**UNITED STATES
NUCLEAR REGULATORY COMMISSION
ADVISORY COMMITTEE ON REACTOR SAFEGUARDS
WASHINGTON, DC 20555 - 0001**

SUBJECT: MINUTES OF THE 565th MEETING OF THE ADVISORY
COMMITTEE ON REACTOR SAFEGUARDS (ACRS),
SEPTEMBER 10-12, 2009

**ACRS License Renewal Committee Meeting
September 10, 2009**

FIGURE 1

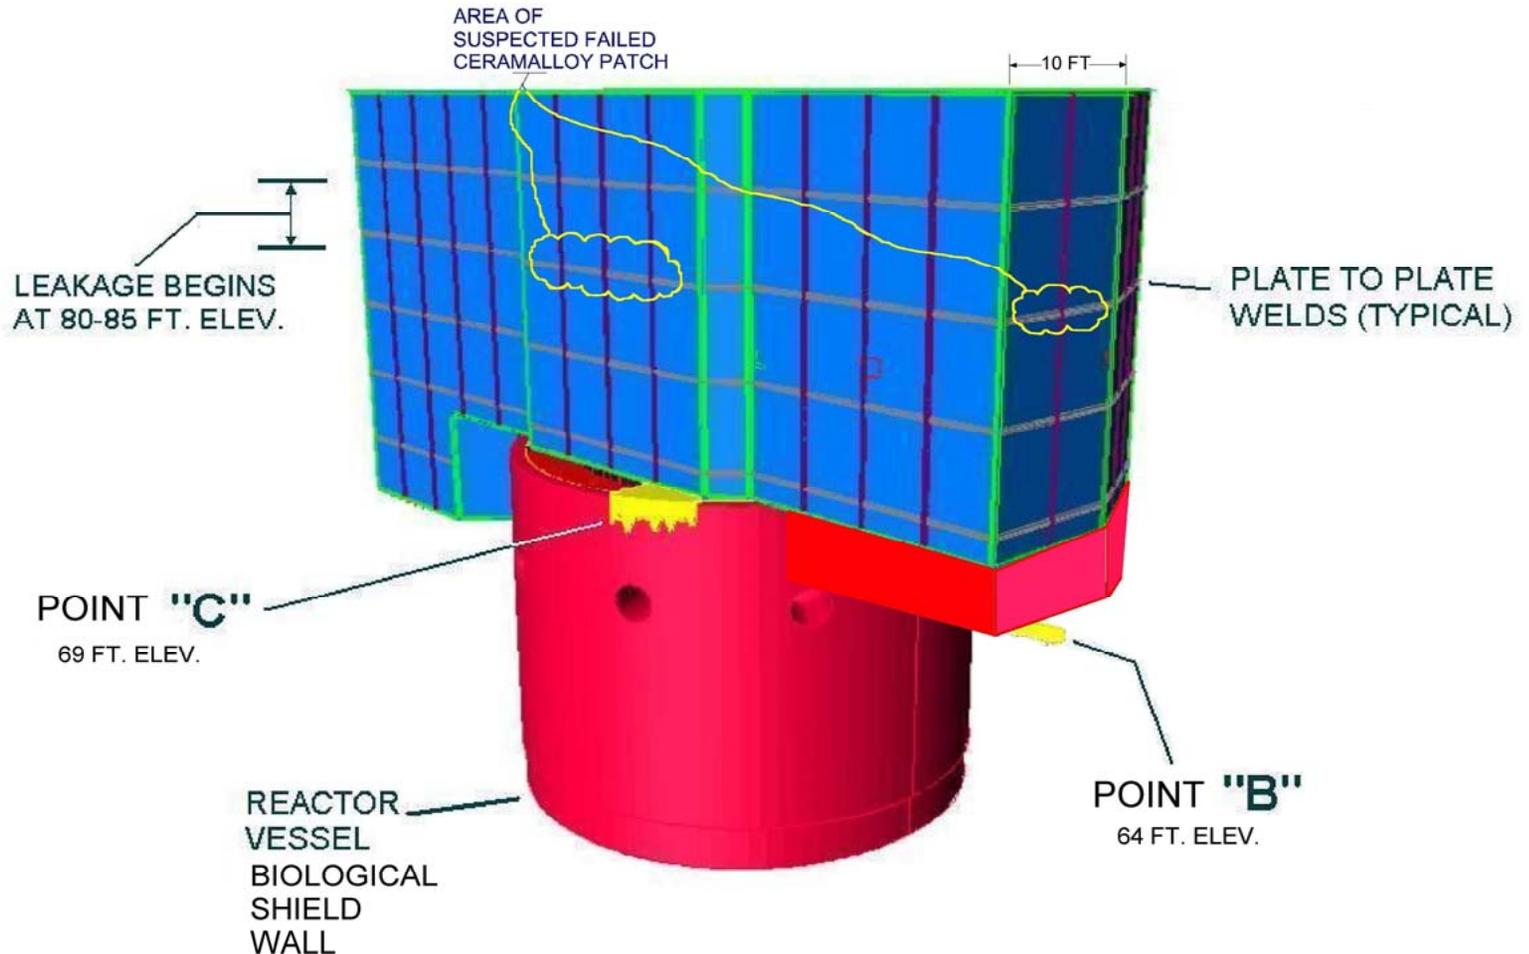
ACRS requested information about the safety significance of the leak and better figures to show the flow paths.

- The refueling cavity begins to leak when the cavity has been filled to between 80' and 85'.
- Leakage occurs from three primary areas.
- Leakage is collected in sump and pumped to liquid radwaste processing system

Unit 2 Source Map

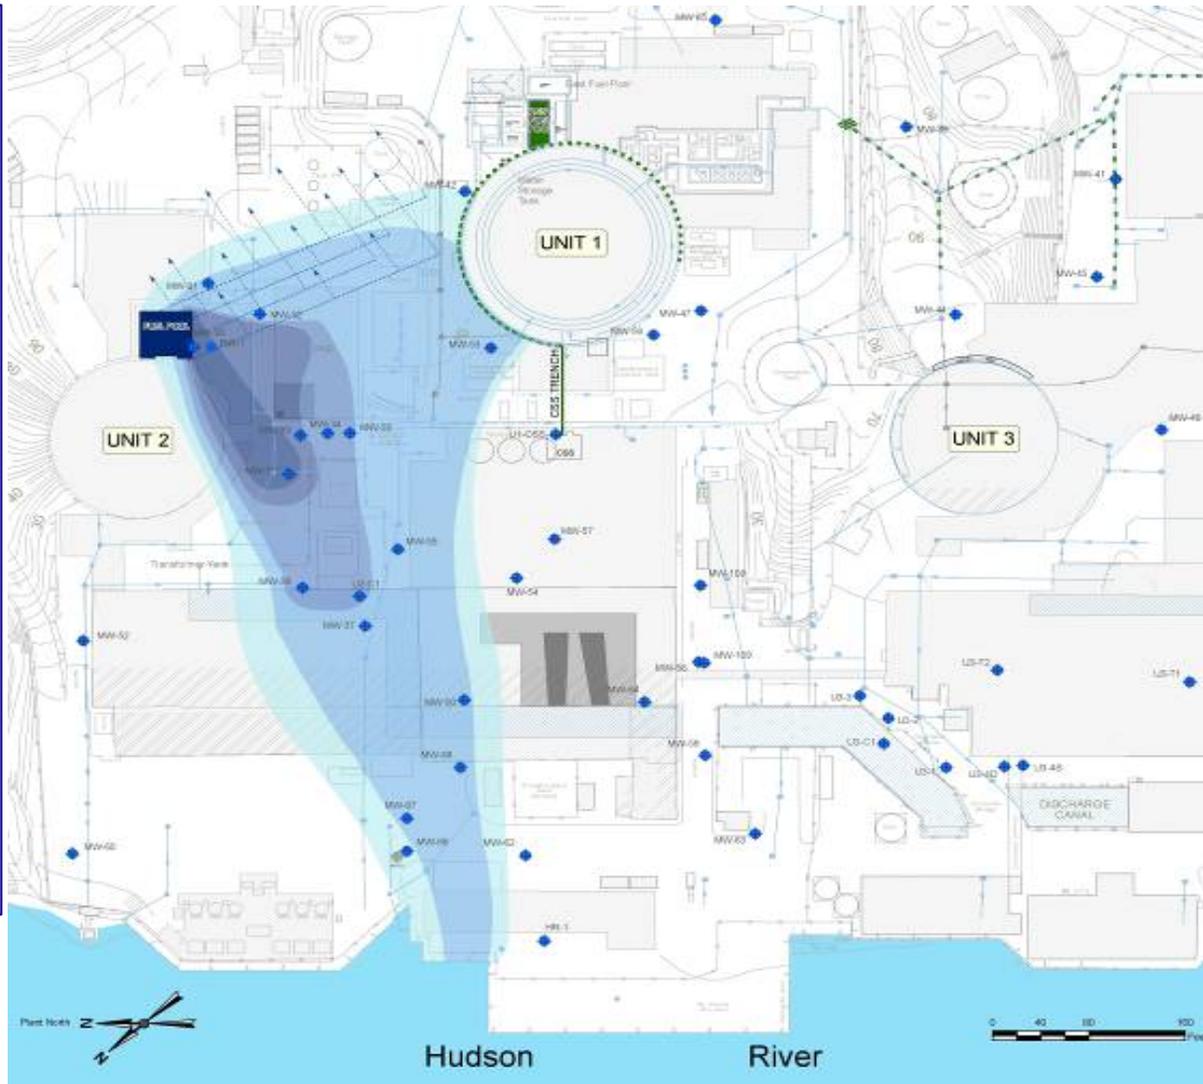
ACRS asked the applicant to bring more detailed hydrologic plume data for the IP2 spent fuel pool.

GW flow is west to river

Wells provide “sentinel” and broad base monitoring

Detection capability of leak near pool confirmed via dye testing
